Service Bulletin Computer Monitors

Model: GDM-17SE1, GDM-20SE1

No. 125

Subject: No Picture due to loss of CRT Heater Voltage

IC604 MARKINGS

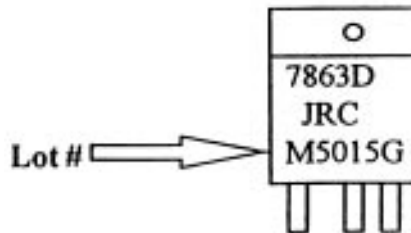
If the screen is dark, this may be due to loss of CRT heater voltage caused by IC604 failure on the G Board. Effected units have IC604 marking shown in the illustration below. Units with IC604 corrected have green labels affixed to the G Board shield case and to the information label on the rear panel.

1. Check the Lot No. on IC 604. See illustration below.

2. If the Lot No. of IC604 is "**M5015G**", then replace IC604 with the new component.
3. If IC604 was replaced, then mark the unit by affixing a small (6-10 mm) green label to the G Board shield case. Also, affix a small (6-10 mm) green label to the information label on the rear panel of the unit.
